**Proposal #11: 1300-13-74**  
**Lakefront Gateway**  
**IH 794 Ramps at Lincoln Memorial Drive**  
**IH 794**  
**Milwaukee County**

This is Addendum No. 02, which provides for the following:

## ADDENDUM NO. 02

Addendum No. 02  
ID 1300-13-74  
Revised Sheet 58  
October 22, 2015

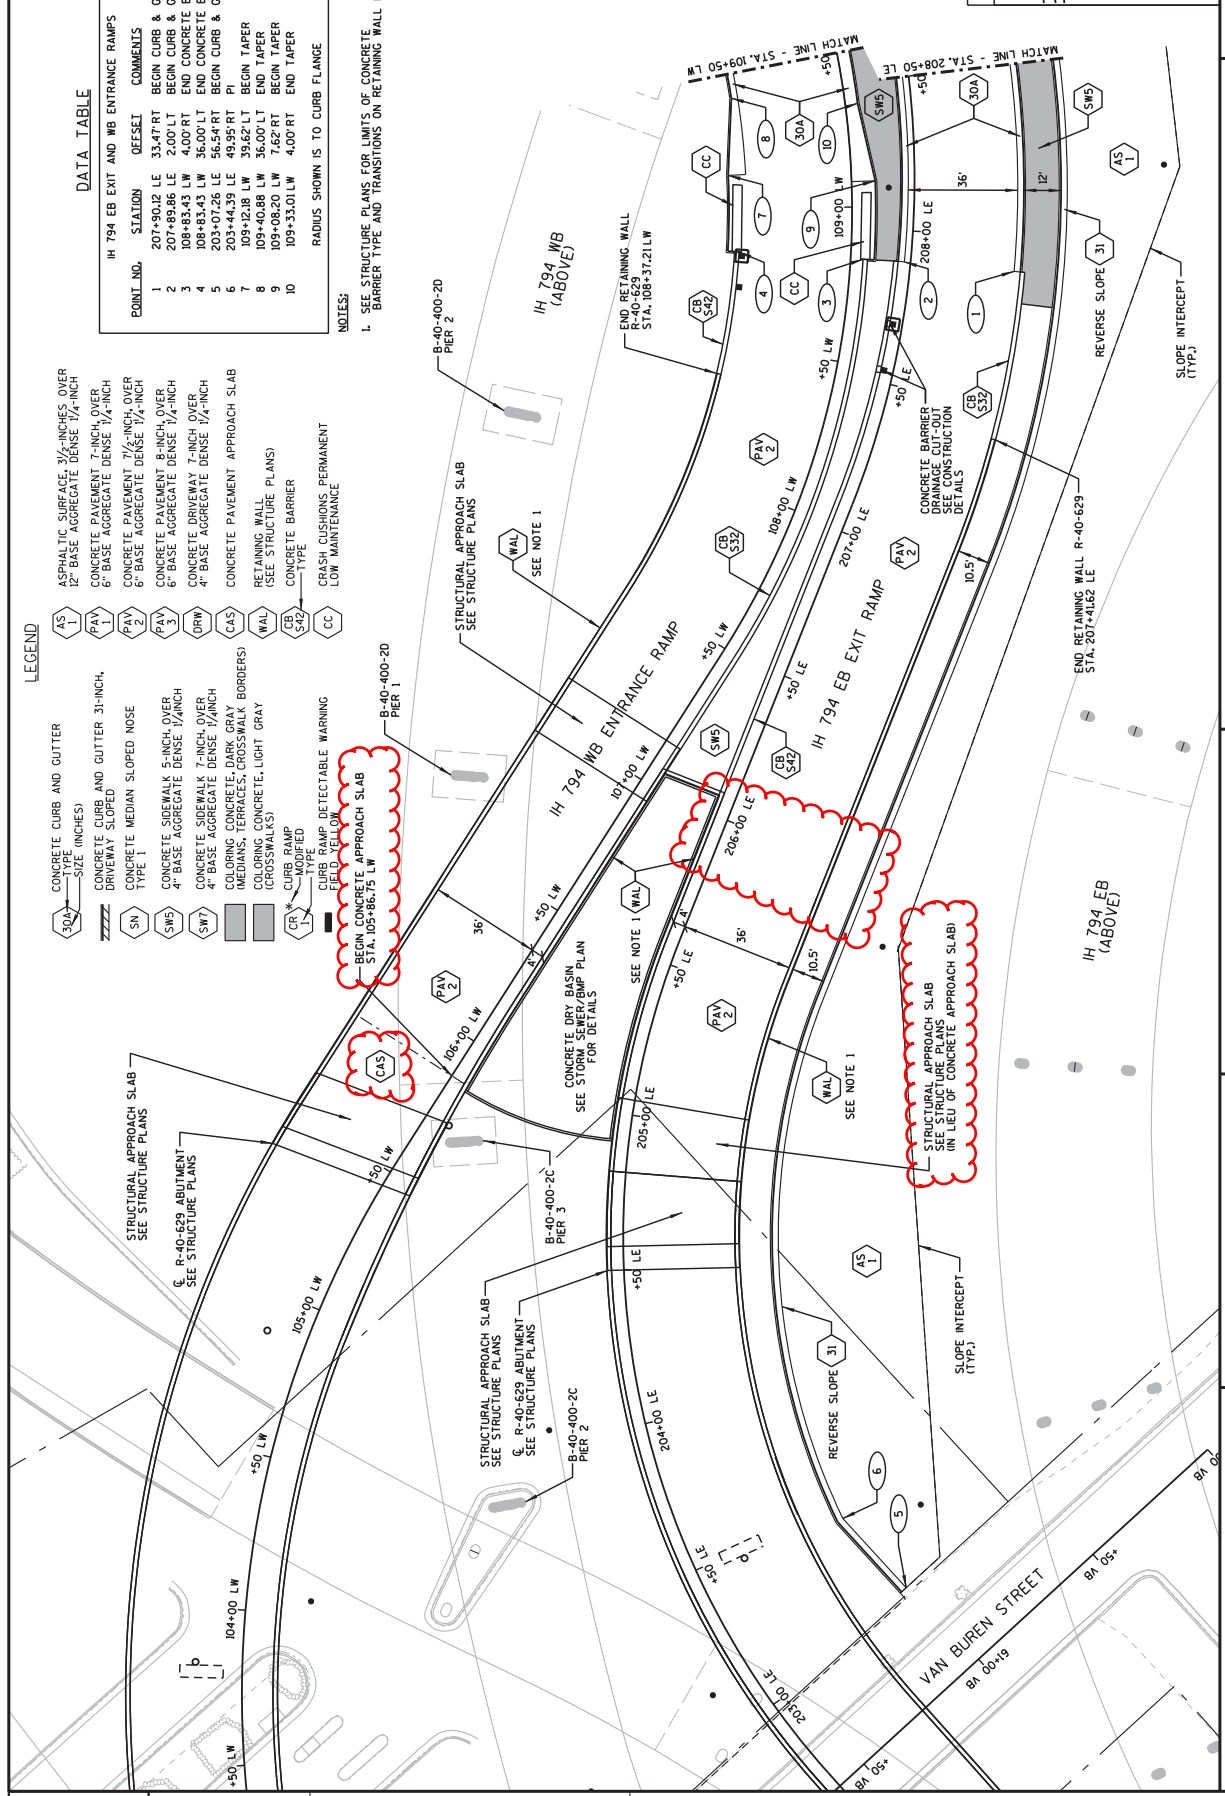
<b>Revised Plan Sheets</b>	
Plan Sheet	Plan Sheet Title (brief description of changes to sheet)
58	Concrete pavement approach slab added on Ramp LW. Note for structural approach slab corrected on Ramp LE.
390	Updated MQ table for Concrete Pavement Approach Slab bid item
391	Updated MQ table for Concrete Pavement 7 ½-Inch bid item
746	Total Estimated Quantity table on the sheet updated to include new Metalizing bid item and added Bridge Seat Protection non-bid item.
764	Note added to identify a portion of the girders are to be metalized.
786	Total Estimated Quantity table on the sheet updated to include new Metalizing bid item.
809	Note added to identify a portion of the girders are to be metalized.

- CR CURB RAMP MODIFIED
  - CR 542 CURB RAMP DETECTABLE WARNING FIELD - YELLOW
  - 31 BEGIN CONCRETE APPROACH SLAB STA. 105+86.75 LW
  - 32 END CONCRETE APPROACH SLAB STA. 105+86.75 LW
